387509

INSTALLATION INSTRUCTIONS

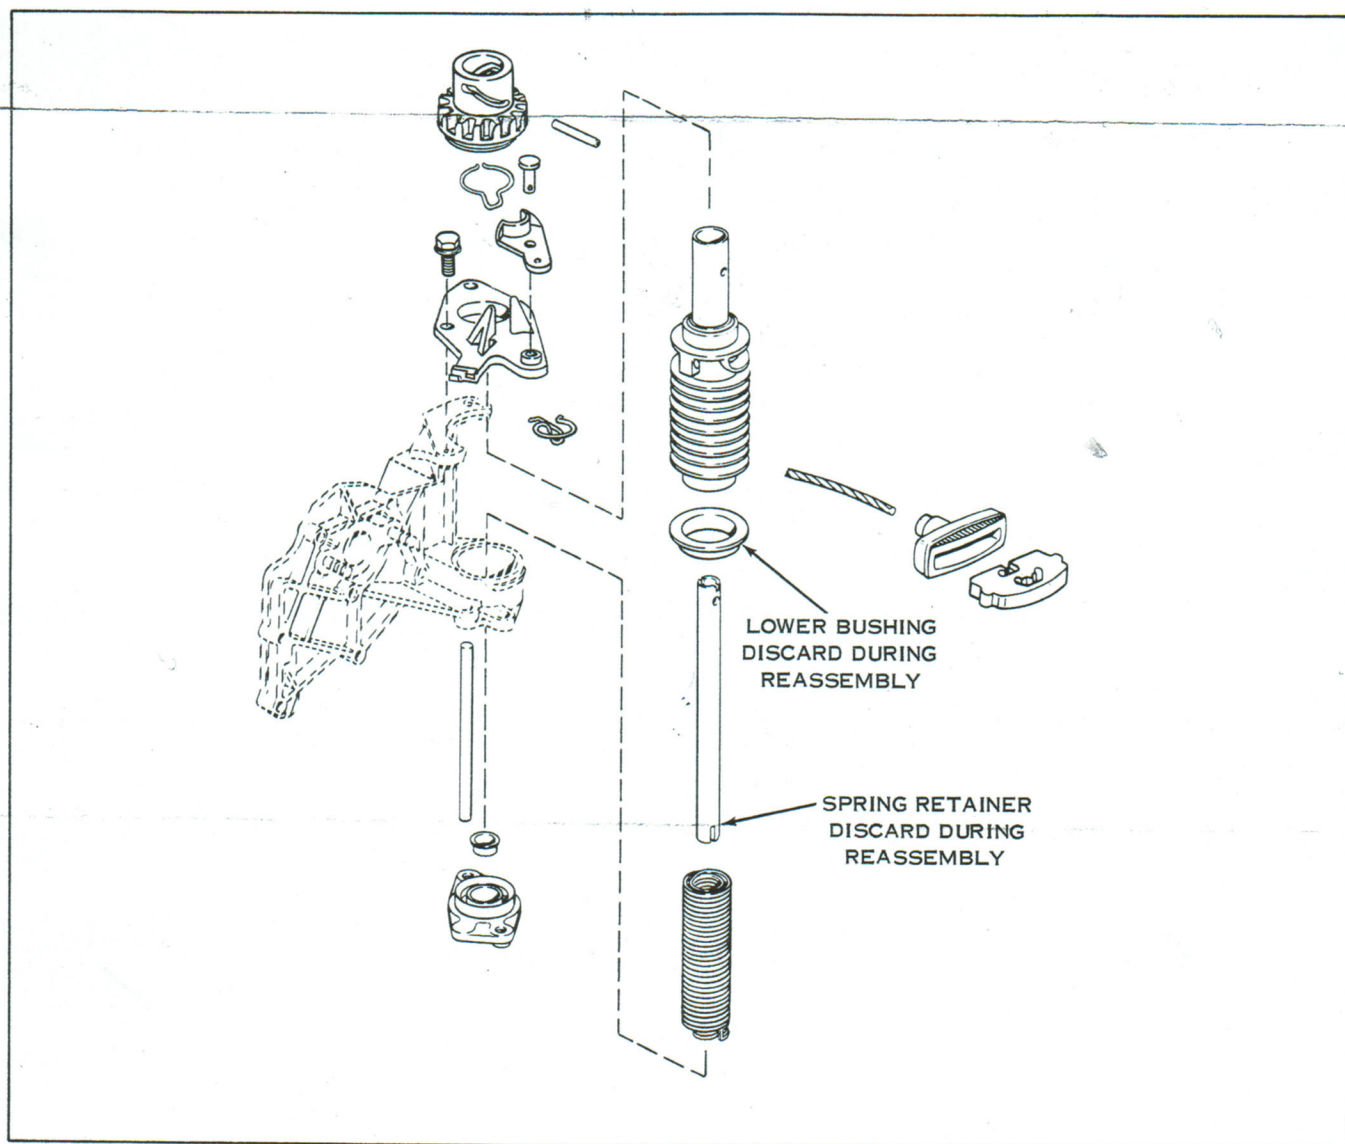
1. When using this spool as a service replacement on models which have an aluminum spool, the original lower bushing and spring retainer are not used.
2. This spool uses a slightly shorter starter rope. Cut rope to 51-3/4" (131.5 Cm).
